V2500-A1/A5 SERIES PROPULSION SYSTEMS SERVICE BULLETIN

This document transmits the Revision 2 to Service Bulletin V2500-ENG-73-0198 and the Revision 2 to the Supplement

V2500-ENG-73-0198

ENGINE FUEL AND CONTROL – FUEL SYSTEM AIR TUBE – INTRODUCTION OF RE-ROUTED BURNER TO
ENGINE ELECTRONIC CONTROLLER (EEC) PRESSURE (PB) SENSE LINE TUBE ASSEMBLIES

Clip position CP0590
Figure 36

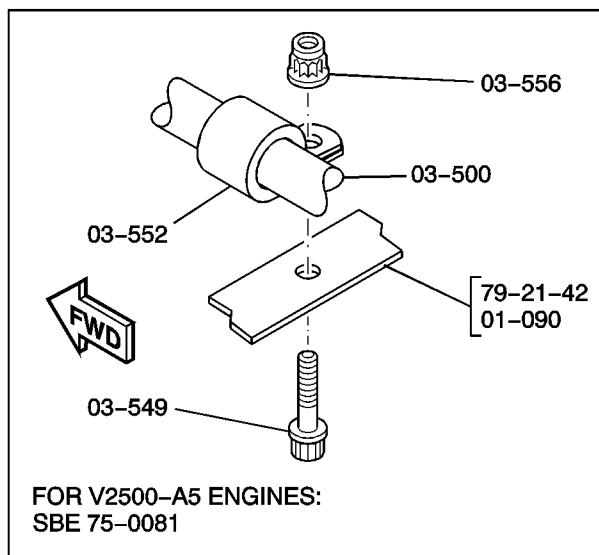
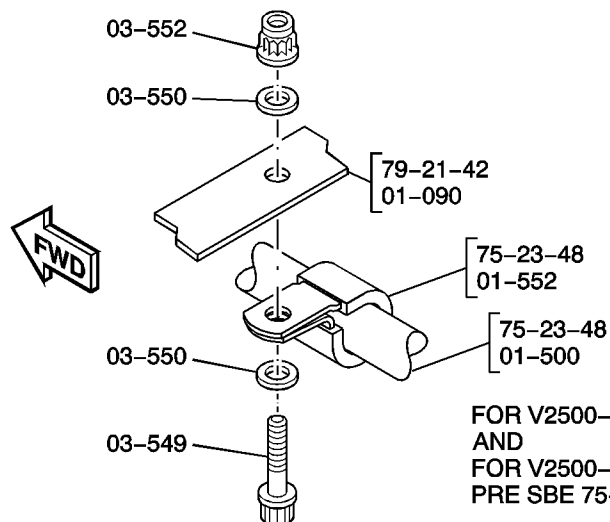
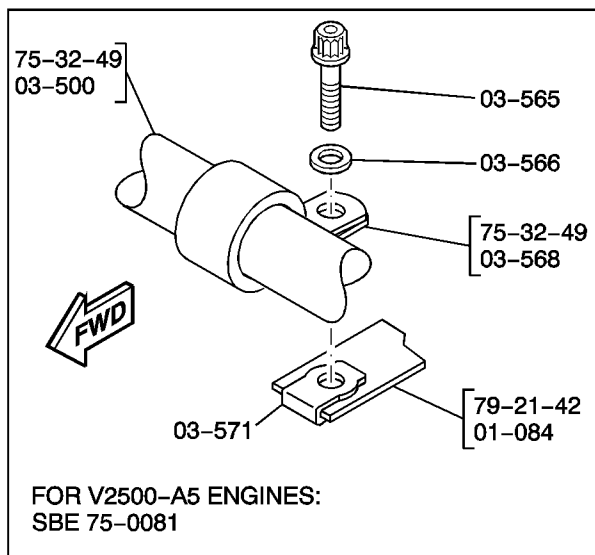
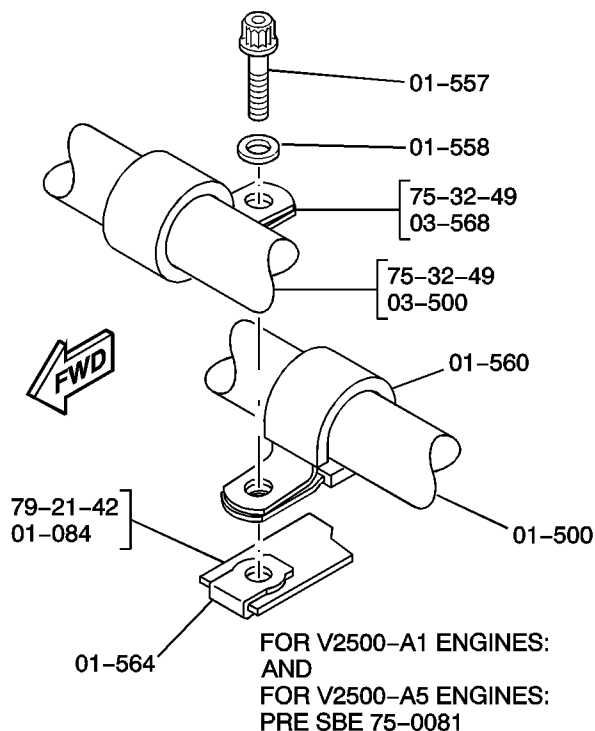
(3) At the revised clip position CP0590:

- A Remove the old bolt (75-32-49, 03-549), the two washers (75-32-49, 0-550) and the nut (75-32-49, 03-556) that attach the two clips (75-32-49, 03-552) and (75-23-48, 01-552) to the bracket (79-21-42, 01-090).
- B Remove the old clip (75-32-49, 03-552), P/N 400WSS4 from the tube (75-32-49, 03-500).

- (5) Torque the nuts at the clip positions CP1403, CP1404, CP1030, CP1029 and CP0590 to between 36 and 45 lbf in. (4 and 5 Nm).
- (8) Make sure that the work area is clean and clear of tools, equipment and other unwanted materials.
- C. Recording Instructions
- (1) A record of accomplishment is required.
